Re: Site Plan Application SPPL2025233
2148 Highway 3 - Roll Number 3310.491.028.07800
Responses to September 16, 2025 Letter

| COMMENT RESPONSE MATRIX | | | |

SITE PLAN APPLICATION SPPL2025233 2148 HIGHWAY 3 – ROLL NUMBER 3310.491.028.07800

Site Plan Application SPPL2025233

A1.01

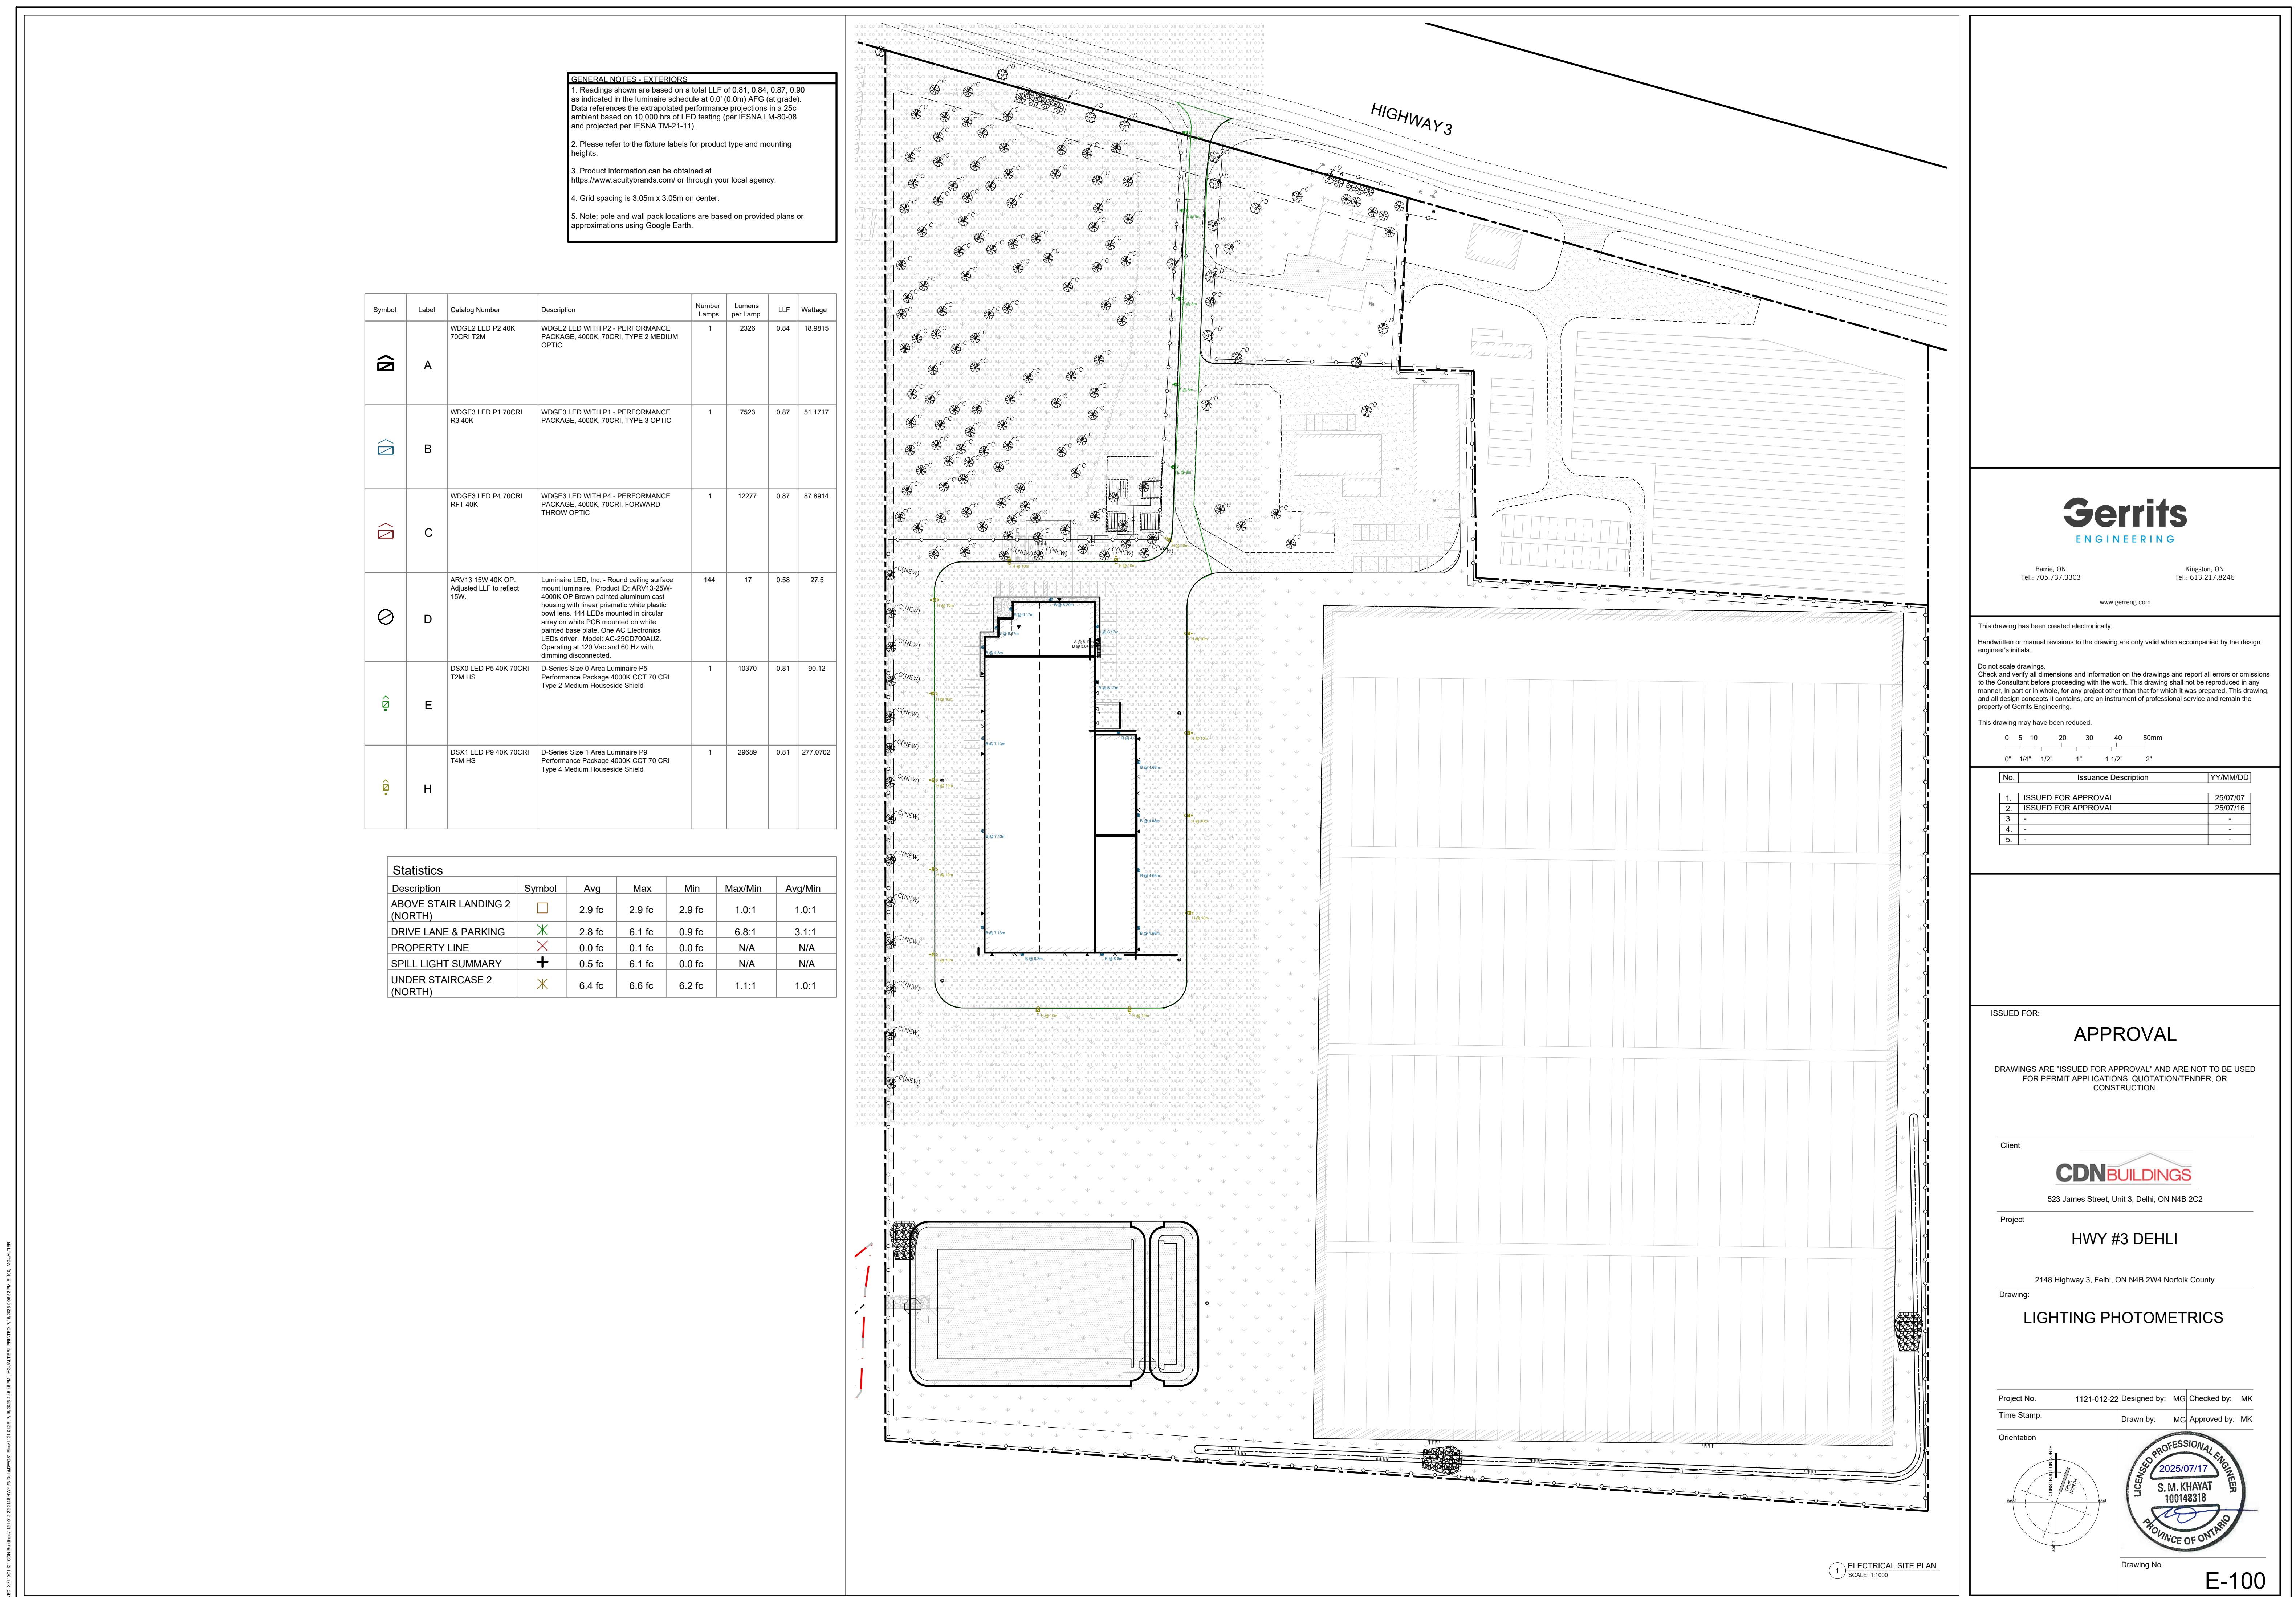
| COMMENT RESPONSE MATRIX | | | |
|---|--|--|----------------------|
| Planning and Realty Services Department | Scale | Complete - added | A1.01 |
| | North Arrow | Complete - added | A1.01 |
| | Development Name | Complete - added | A1.01 |
| | Owner name, address, and telephone number | Complete - added | A1.01 |
| | Zoning compliance table - required vs. proposed | Complete - added | A1.01 |
| | Mark entrances to parking areas with arrows | Complete - added | A1.01 |
| | All setbacks of buildings and structures to property lines | Complete - added | A1.01 |
| | Septic system setbacks from lot lines and existing and proposed structures | Complete - added | A1.01 |
| | Refuse disposal and storage areas (if indoors, need notation on plan) | Complete - added | A1.01 |
| | Snow storage locations | Complete - added | A1.01 |

| COMMENT RESPONSE MATRIX | | | |
|-------------------------|---|--|----------------------------------|
| | Provide setback and building height information for proposed buildings in site statistics table | Complete - Table provided on site plan for zoning provision compliance | A1.01 |
| | Parking access aisles for parking spaces need to be 7.3m for two way traffic. | Complete - Revised and provided on site plan. | A1.01 |
| | Parking is deficient by 13 parking spaces, 108 total parking spaces required. | Complete - Revised to 108 total parking spaces provided. | A1.01 |

Drawing No. SG-1

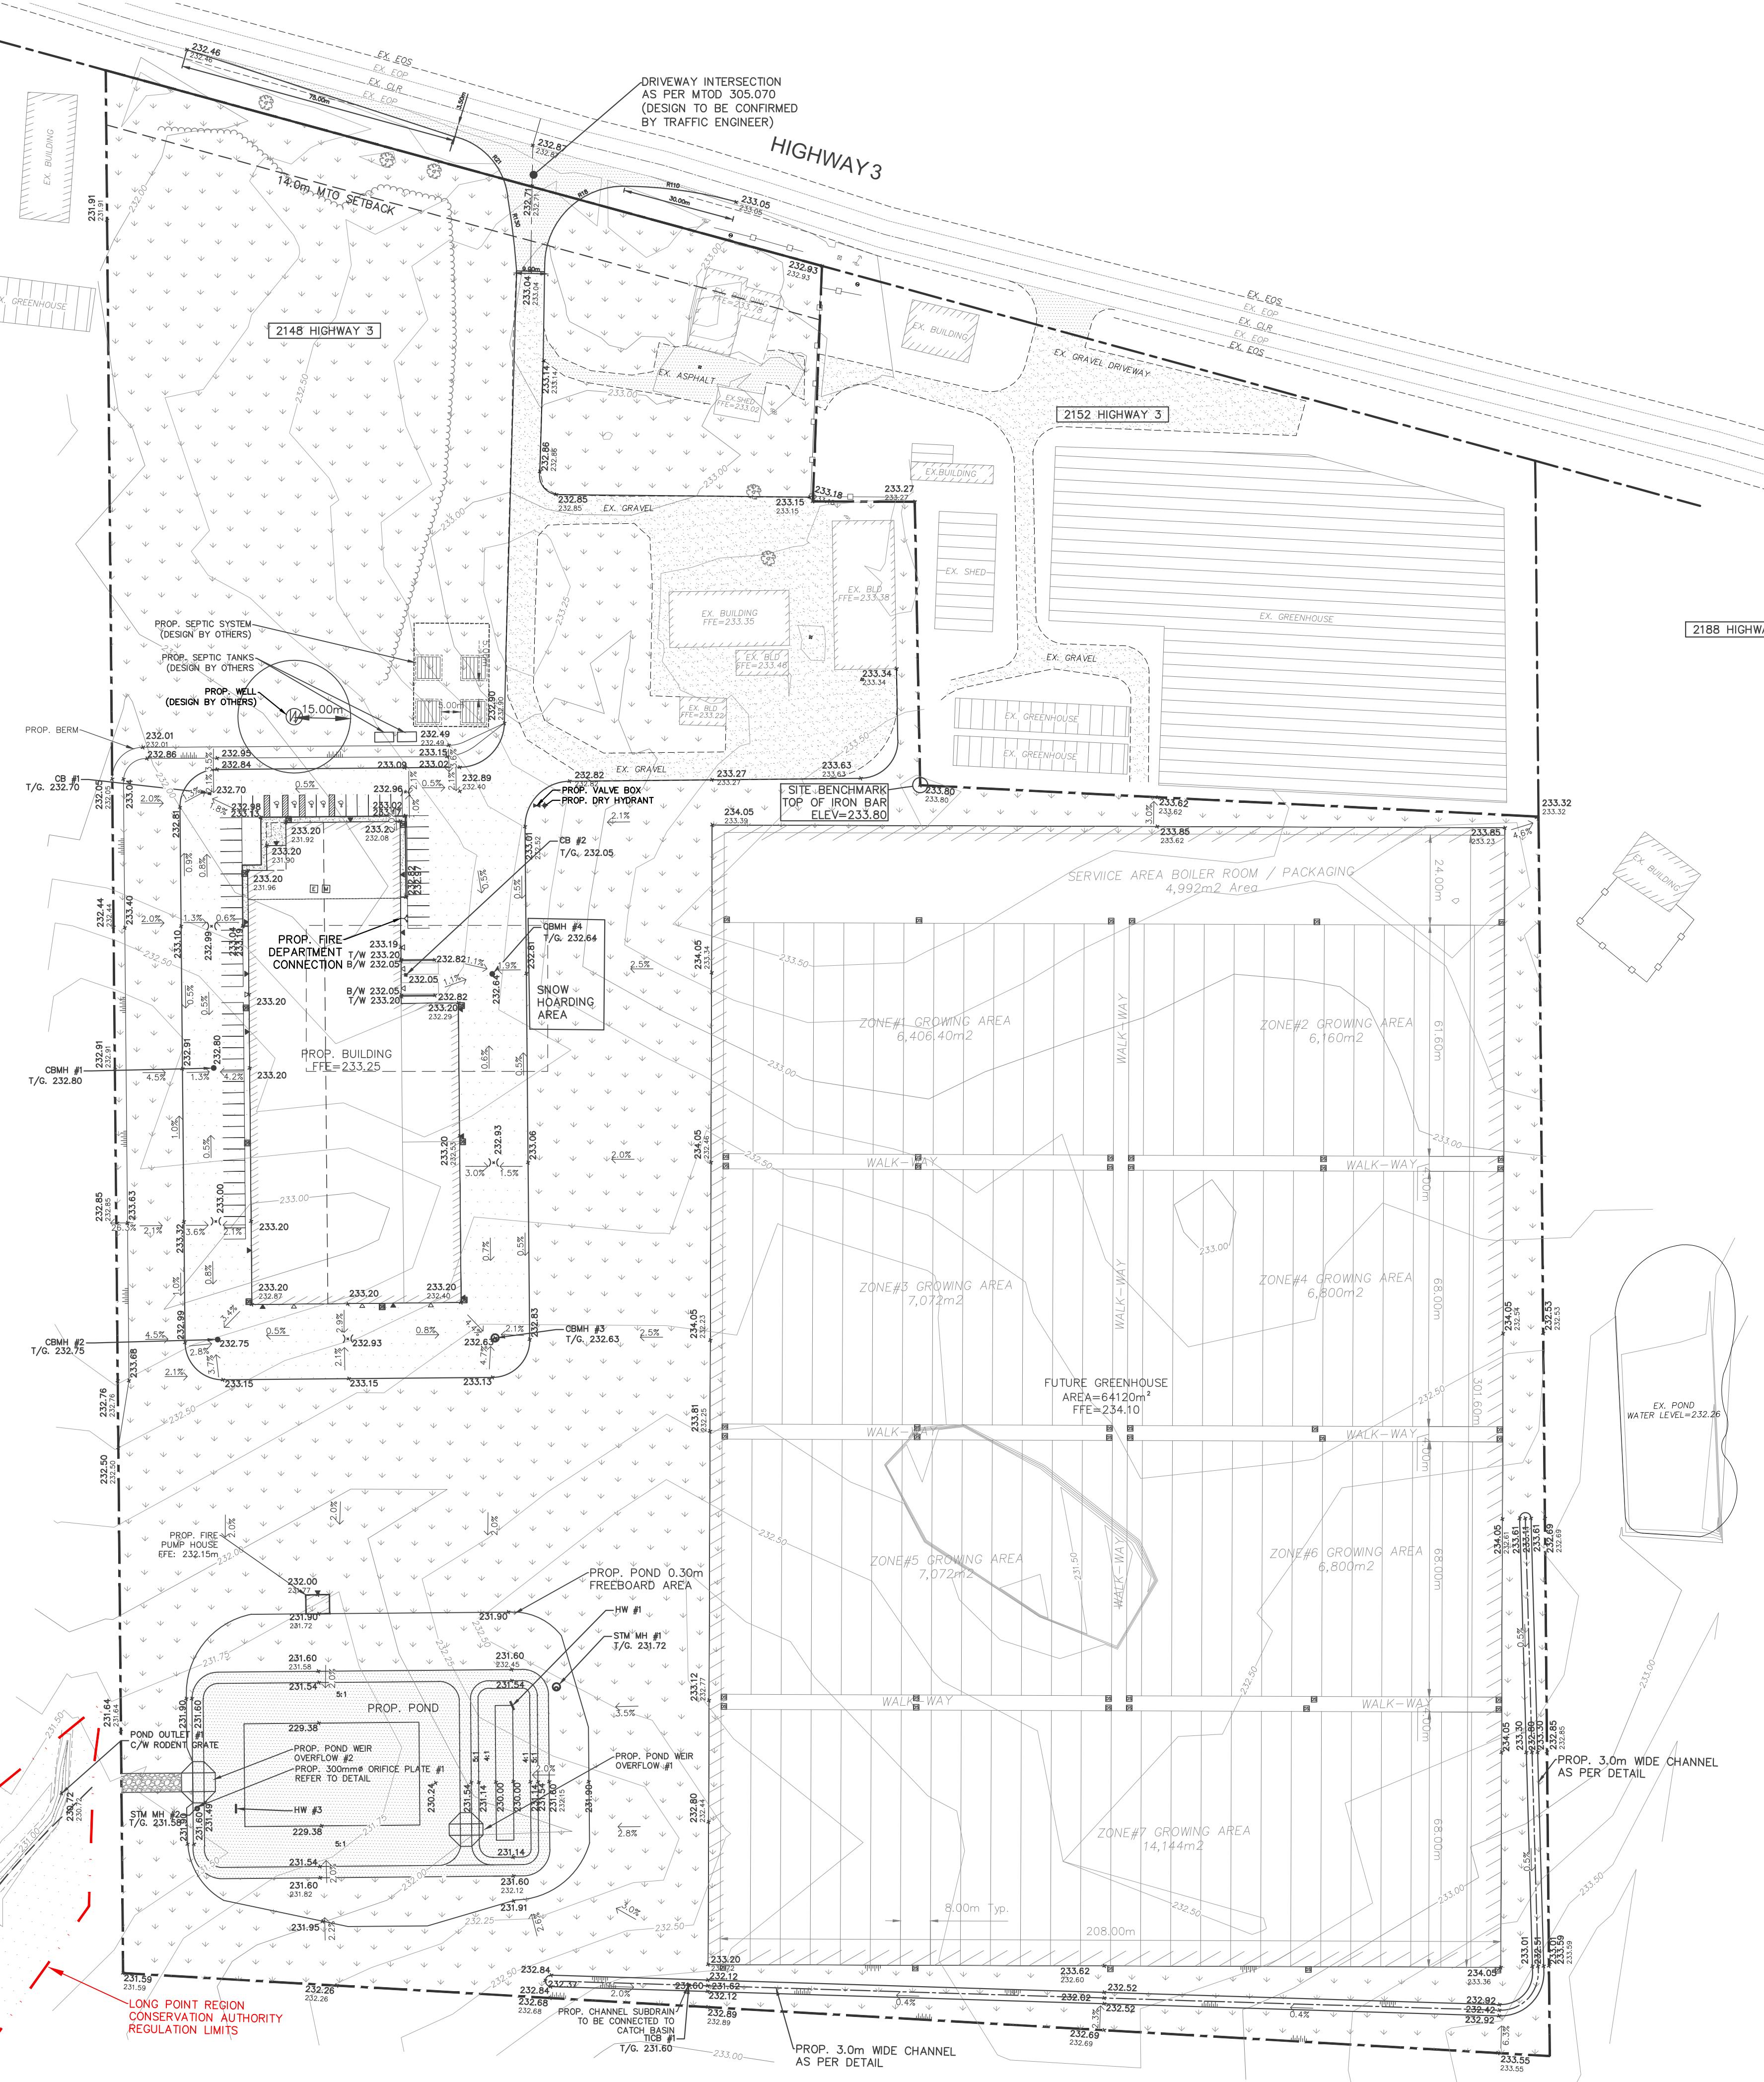
Comment #5: Driveway entrance is to be paved from edge of asphalt to property line and constructed per Norfolk County Design Criteria 6.7.01: COMMERCIAL, LIGHT INDUSTRIAL AND APARTMENTS

Comment #7: Per Norfolk County Design Criteria 11.3.00, rear and side yard swales shall have a minimum slope of 2.0%

- Response: Notes and detail page has been updated to include Driveway entrance pavement structure.

- Response: Due to the existing elevations and pond outlet location, we are unable to meet the minimum slope of 2.0% for 3.0m channel. We have include a detail which includes rip rap and subdrain to ensure drainage is directed towards the proposed storm pond.
